## 《基礎作業守則 2017 年》 修訂事宜

**Amendments to the Code of Practice for Foundations 2017**  
**( July 2022 )**

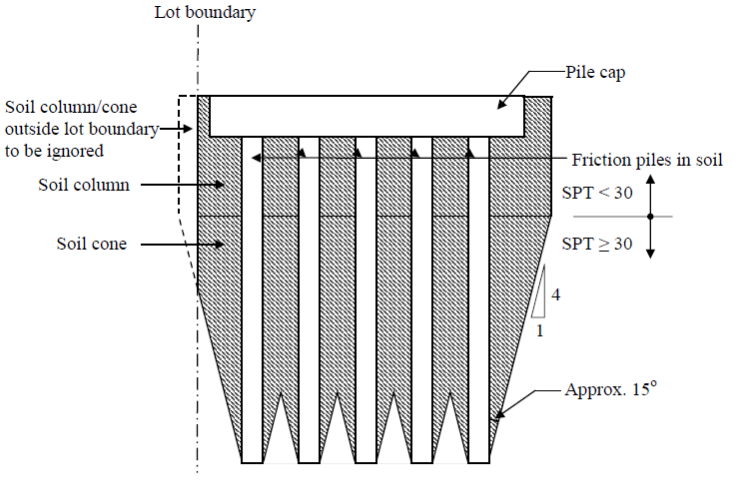
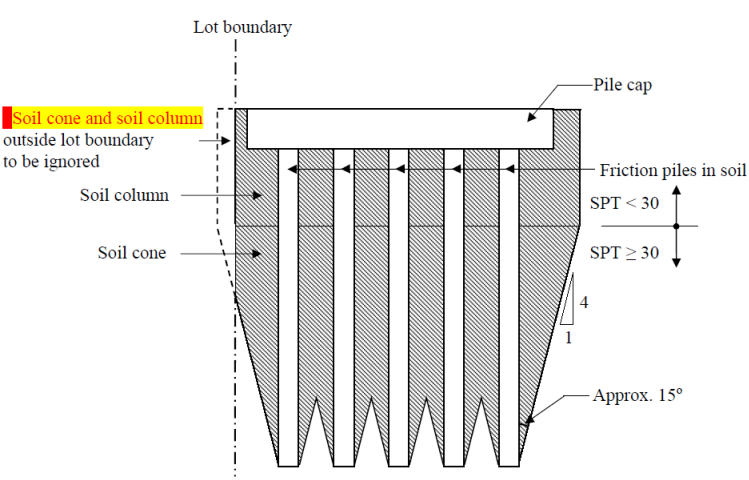
Item	Current version	Amendments
<p>4. Figure 5.1<sup>6</sup></p>	<p>(a) Single Rock Socketed Piles</p> <p>(b) Group of Closely-Spaced Rock Socketed Piles</p> <p>Figure 5.1 Configuration of Rock Cone/Soil Column for Rock Socketed Piles</p>	<p>(a) Single Rock Socketed Piles</p> <p>(b) Group of Closely-Spaced Rock Socketed Piles</p> <p>Figure 5.1 Configuration of Rock Cone and Soil Column for Rock Socketed Piles</p>

<sup>6</sup> Clarification on the assessment concerning the rock cone and soil column.
